RE: GRADING PLAN SUBMITTAL OF CITY LIGHTS SUBDIVISION RECEIVED
FEBRUARY 17, 1987 FOR FINAL PLAT, ROUGH GRADING, AND WORK
ORDER APPROVAL (J-23/D13) (PROJECT NO. 3184)

TITLE: CITY LIGHTS SUBDIVISION
GRADING PLAN

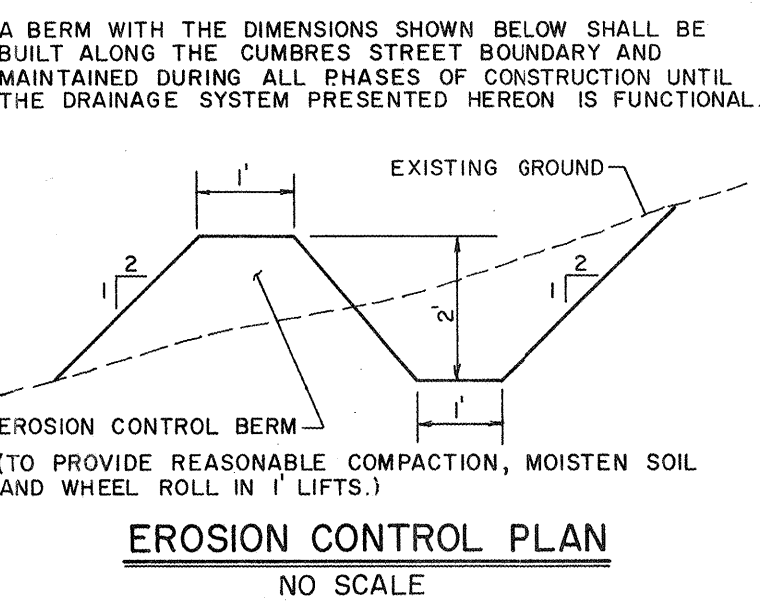
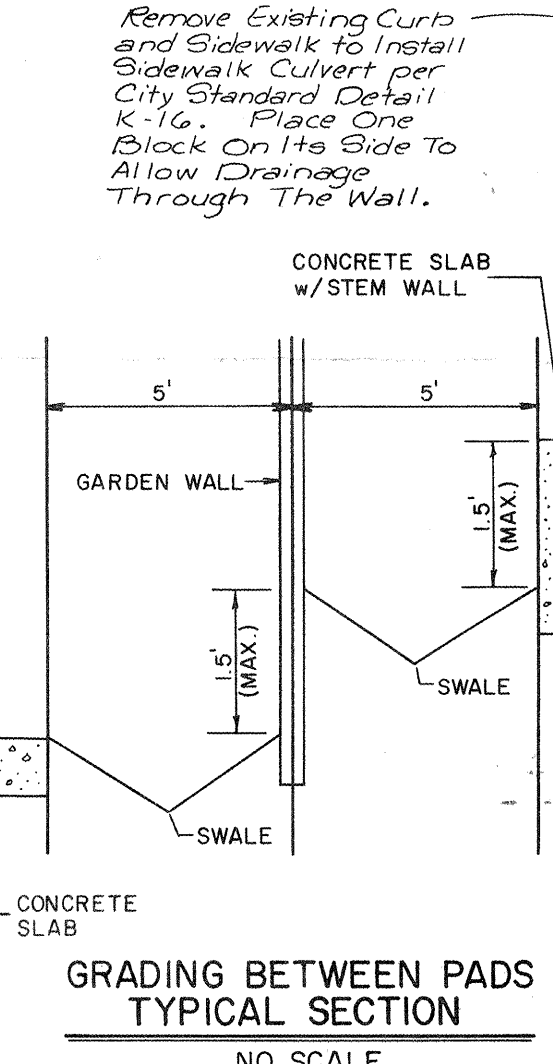
1. Identify the required widths of the three sidewalk
culverts.
2. Clarify which walls, side or perimeter, need one
block on its side in the south east corner of
project site.
